November 8, 2011

Mr. Patrick Alford, Planning Manager
City of Newport Beach, Community Development Park
3300 Newport Blvd.
P.O. Box 1768
Newport Beach, CA 92658-8915

We object to the approval of the Newport Banning Ranch project in its present form. The comments below and all references contained therein are hereby incorporated into the City's official record of proceedings of this project and its successors.

Exhibit 4.1-2f

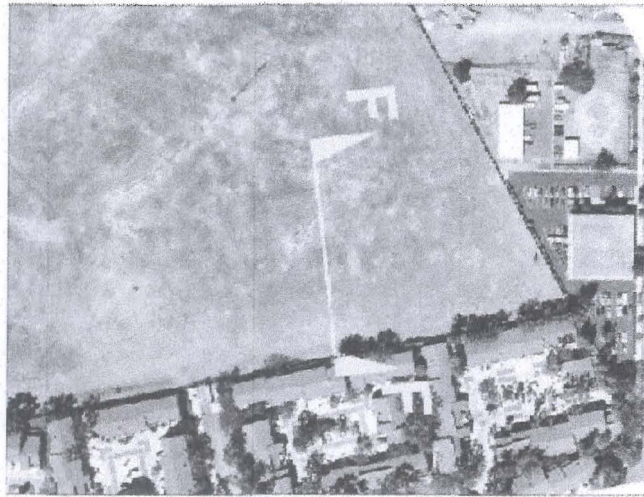
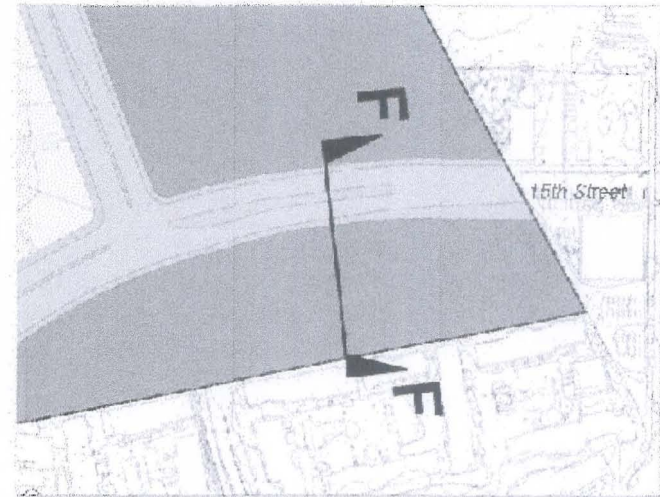
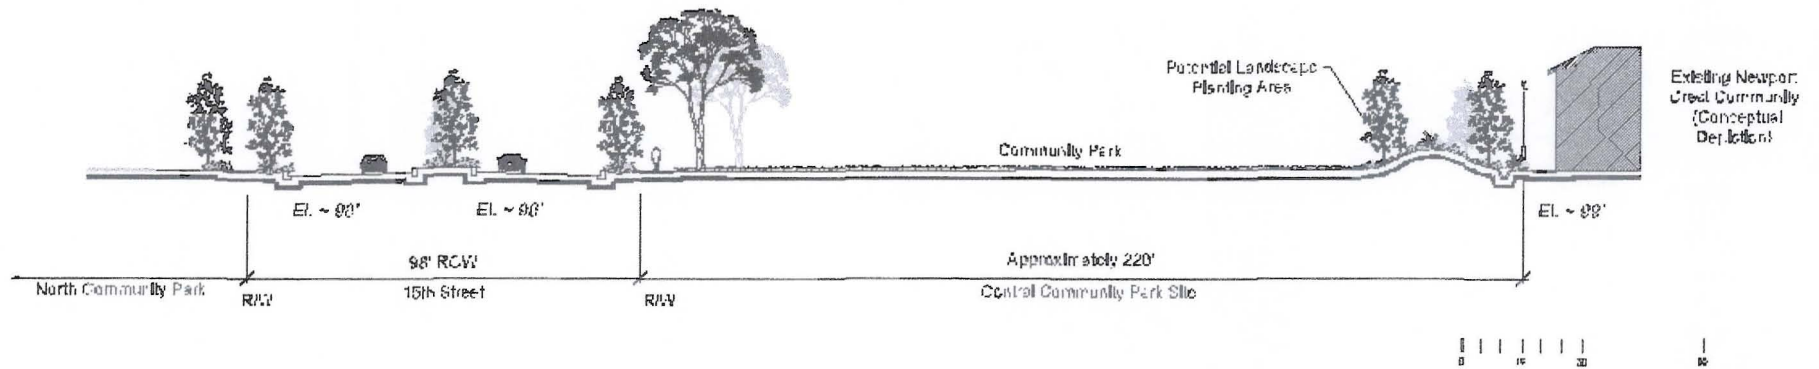
Why does Bluff Road need to be so close to the Newport Crest community? North Bluff Road is located over 300 feet from California Seabreeze, and North Bluff Road is a smaller less traveled road than Bluff Road. Bluff Road is as close as 22' to Newport Crest (see Exhibit 4.1-2g, Central Community Park Interface with Newport Crest' enclosed at end of this document).

Exhibits NBR DEIR 4.1-2f, 4.1-2g, 4.1-2h, and 4.8-3 are included at the end of this document for reference and emphasis.

Based on these exhibits the project comes right to the border of Newport Crest with zero buffer between the Crest and the Community Park. Then the 4-lane primary highway, Bluff Road, then the North Community Park, including the sports fields, restrooms, and surrounding parking lots.

The NBR DEIR failed to examine an alternate road to Bluff Road to reduce the impacts to surrounding communities. EQAC asked that an alternate road plan to Bluff Road be designed. Please include an alternative Bluff Road plan into the revised NBR DEIR as requested by EQAC.

Exhibit 4.1-2g

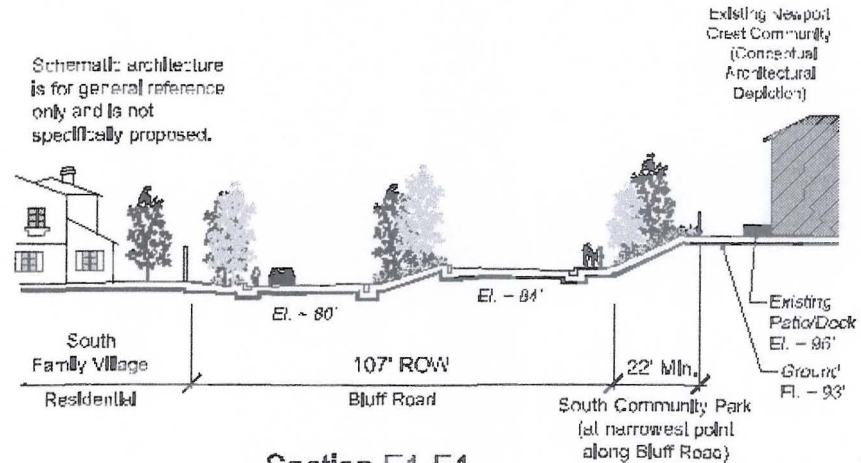
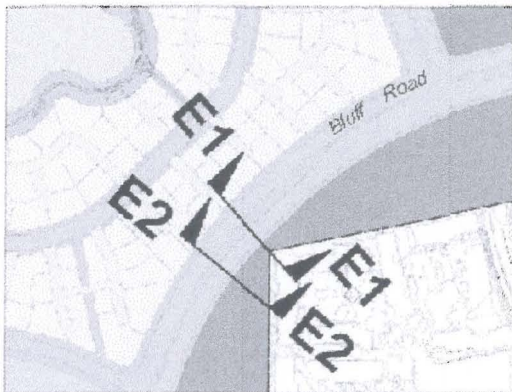
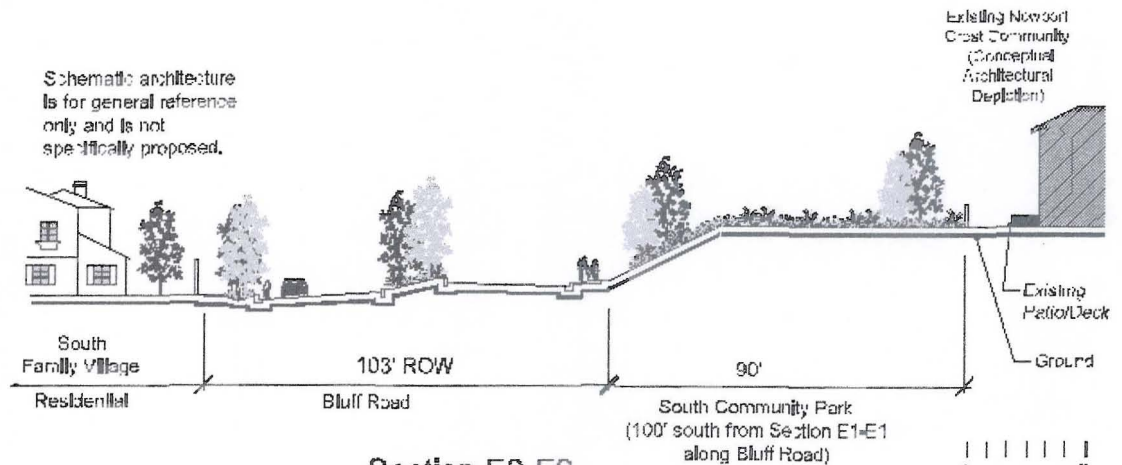
Where in Newport Beach is there a comparable residential project with roads and public parks of the size and magnitude of the proposed NBR that abuts right up to other prior existing residential propert(ies)? Please provide example(s) of these comparable existing residential communities where public parks abut/border other residential communities.

The NBR DEIR needs to be revised to include other park and roadway alternatives that reduce the 'significant unavoidable impacts' of light, noise and air quality to 'less than significant'. Effective mitigation measures and alternatives (e.g., more open space, reduced scope of active sports park, reduced parking, reduced roadway system) all need to be considered.

Exhibit 4.8-3

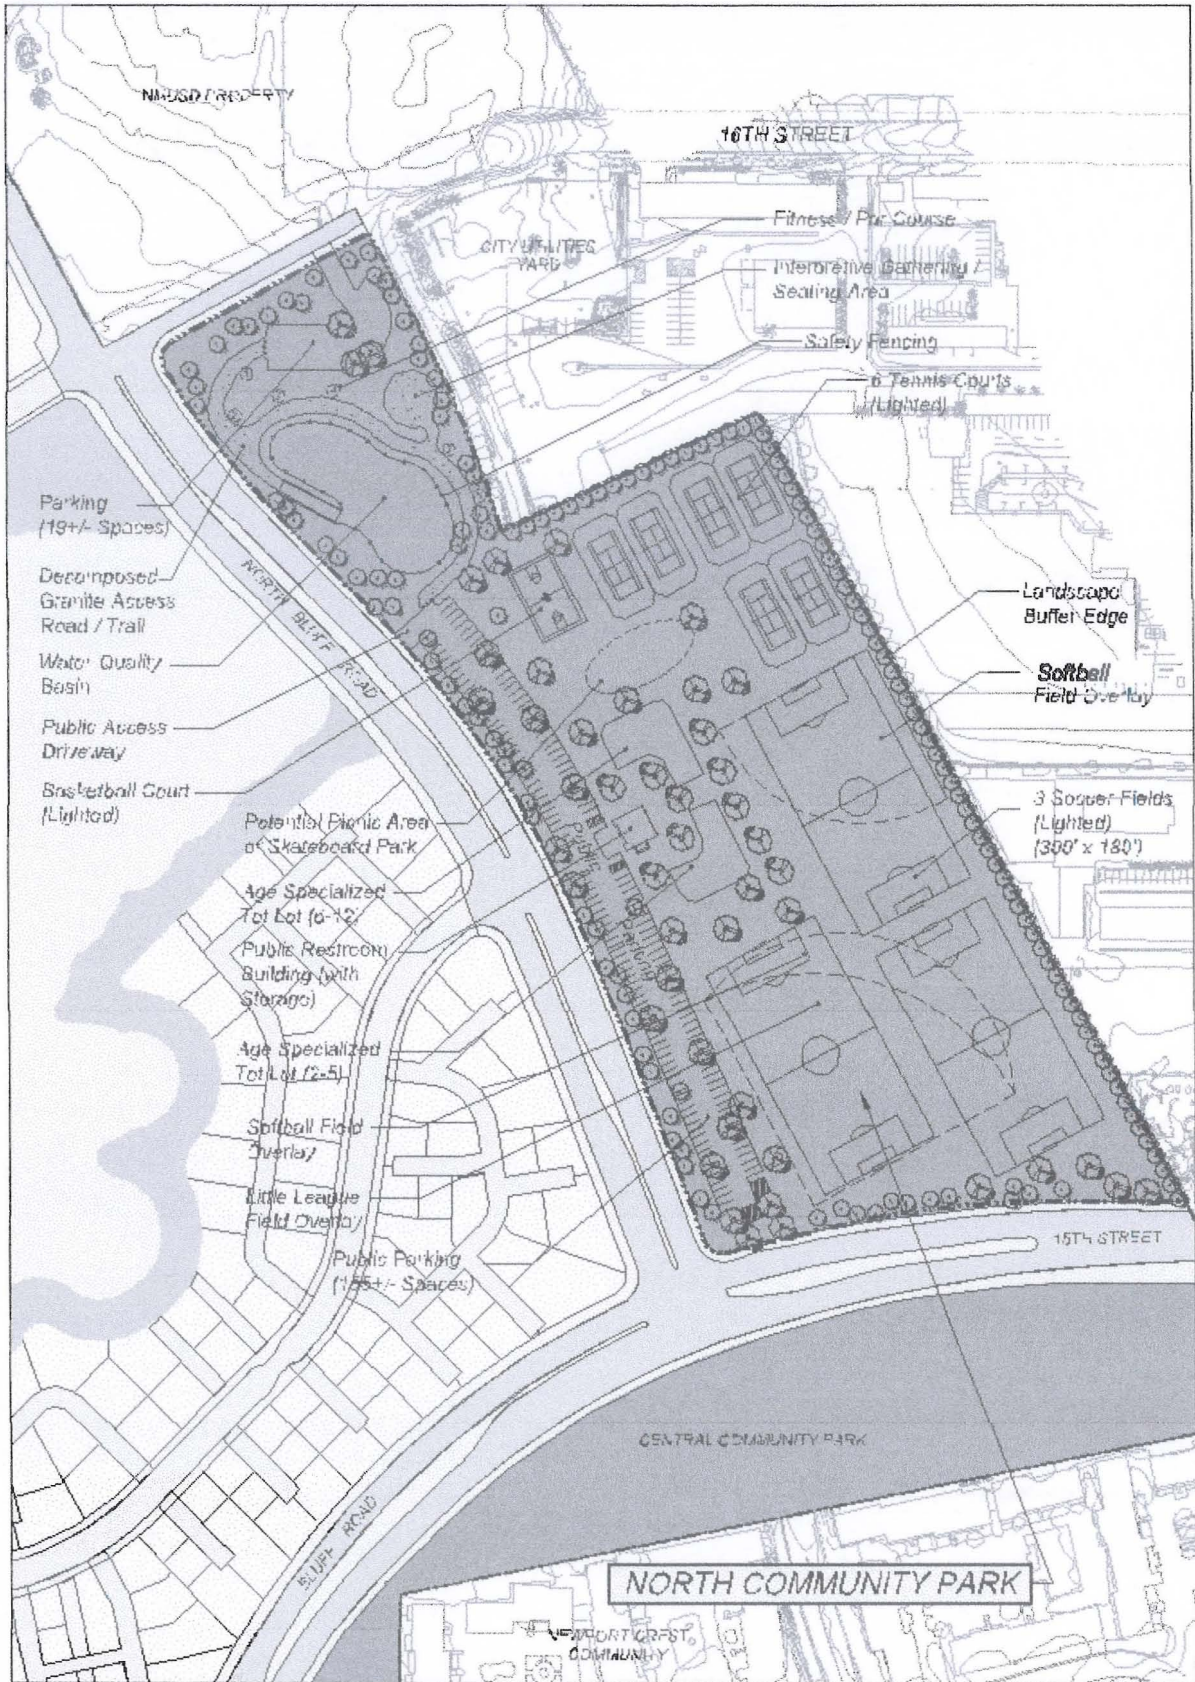
'The North Community Park area (Site Planning Area 7c) is proposed east of North Bluff Road between 15th Street and 16th Street. As depicted on Exhibit 4.8-3, North Community Park Development Plan, the 13.5-net-acre North Central Park area is proposed to include the following recreational uses:

- 6 tennis courts (lighted),
- 3 soccer fields (lighted),
- 1 basketball court (lighted),
- 1 youth baseball fields and 1 youth/adult softball field overlaid on the 3 soccer fields
- (noted above),
- Potential picnic area or skateboard park,
- 2 tot lots, and
- 1 Fitness/par course. (Underlined for emphasis)

The list of recreational uses above seems extreme. Where is the analysis and supporting data that demonstrates the need for all of these 'recreational uses' for this one park? Why hasn't a reduced park design with fewer recreational uses been considered in light of the significant unavoidable impacts this park will have on surrounding communities?

Why can't the Central and North Community Parks that border Newport Crest be designated passive open space nature preserves? This is approximately 10 acres less than 51.4 being offered by the Applicant so the Applicant would still be within Park Dedication Ordinance Requirements?
